AS BUILT 3/1/84

NETC DWG NO. 22932-236

EXTERIOR WALL IMPROVEMENTS
BUILDING NO. 678
NAVAL COMPLEX, NEWPORT RHODE ISLAND

BUILDING ELEVATIONS

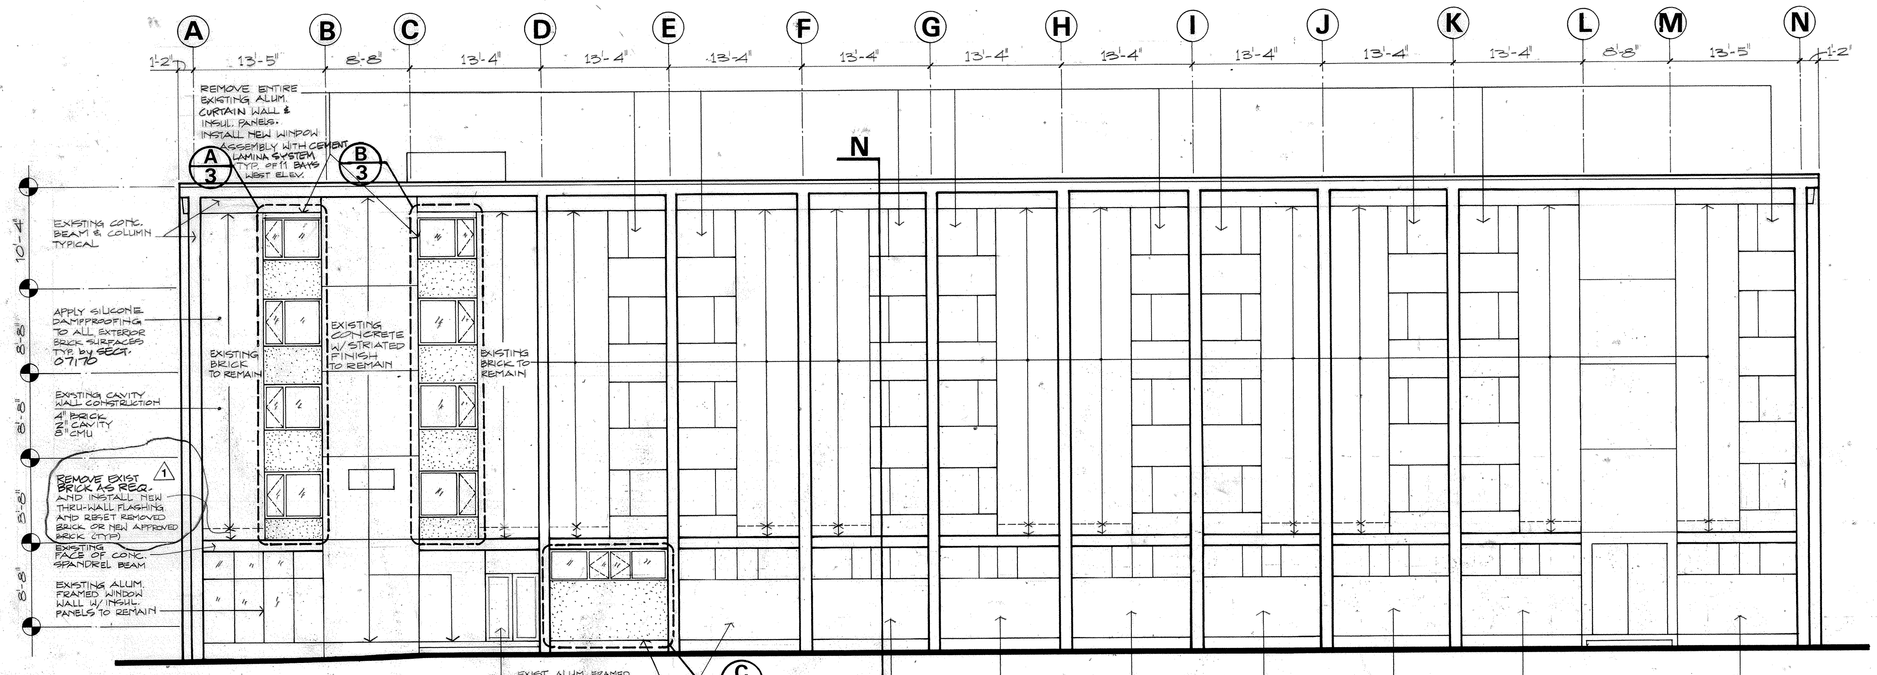
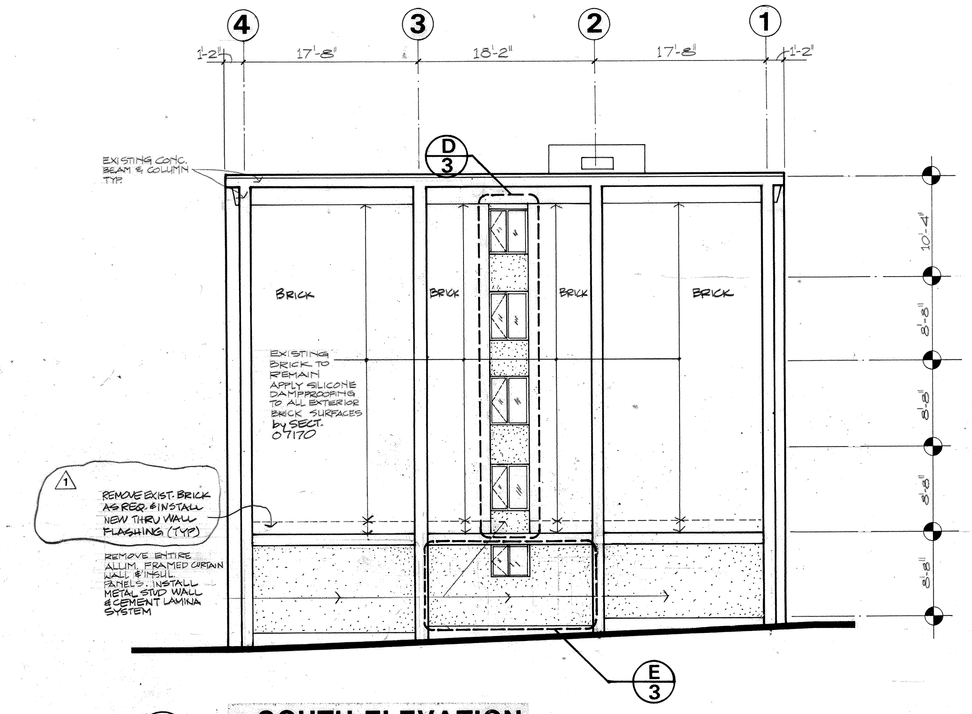
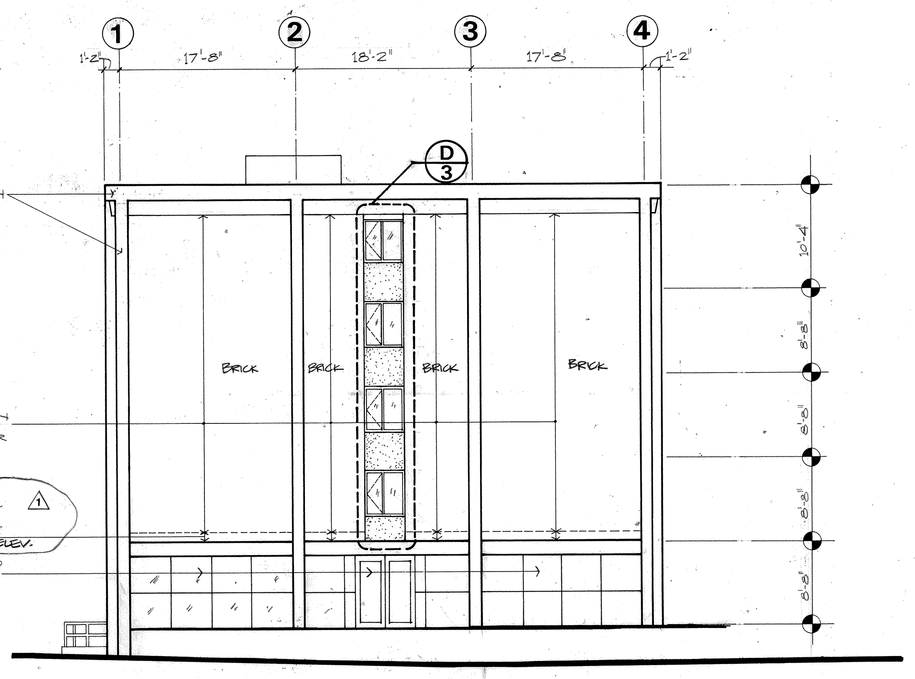
REVISIONS				
LTR.	DESCRIPTION	PREP'D BY	DATE	APPROVED
1	EXISTING BRICK NOT REMOVED. EXISTING THRU WALL FLASHING REMAINED (EXCEPT FOR 5 BAYS ON EAST ELEVATION. SEE B/2)	ASAB	3/1/84

B/2 **EAST ELEVATION**
1/8" = 1'-0"

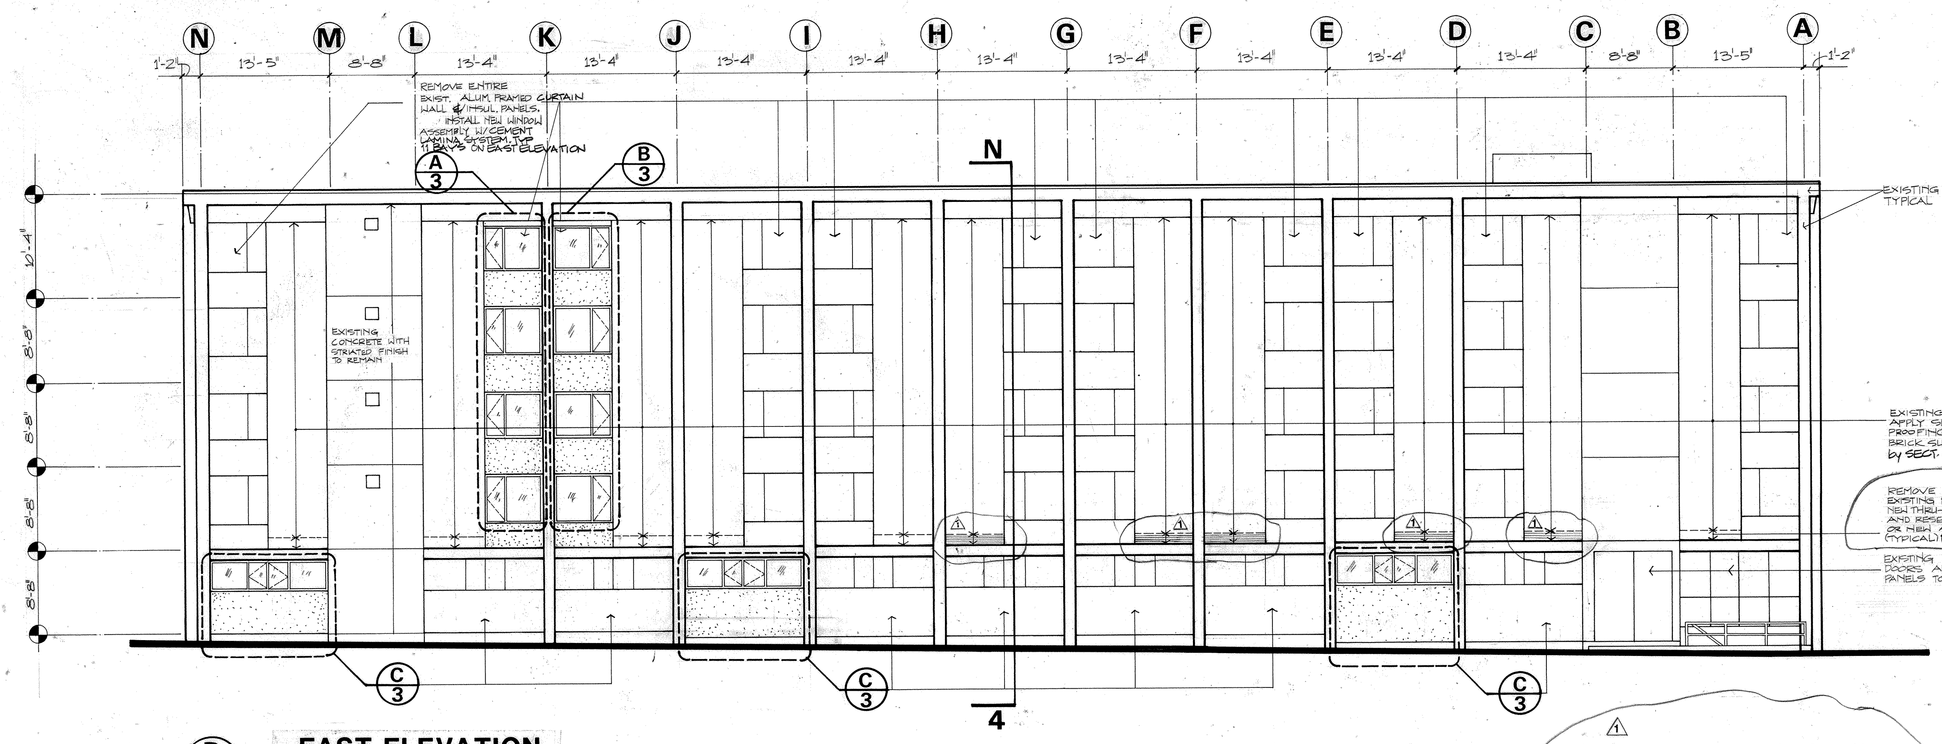
REMOVED & REPLACED EVE SECTIONS ONLY OF BRICK WORK ON EAST ELEVATION TO EXPOSE & INSPECT FLASHING. IT WAS AGREED BY MR. GALLIHER FROM ARCHITECTURAL FIRM OF GALLIHER SCHOENHARDT & BAIER, MR. LOU PAYAN (PROJECT MANAGER) & MR. ROGER PARADIS (FIELD INSPECTOR) THAT THE FLASHING WAS NOT THE CAUSE OF VARIOUS BUILDING LEAKS. REMOVAL OF BRICK WORK & REPLACING WITH NEW BRICK & FLASHING WAS ELIMINATED FROM CONTRACT
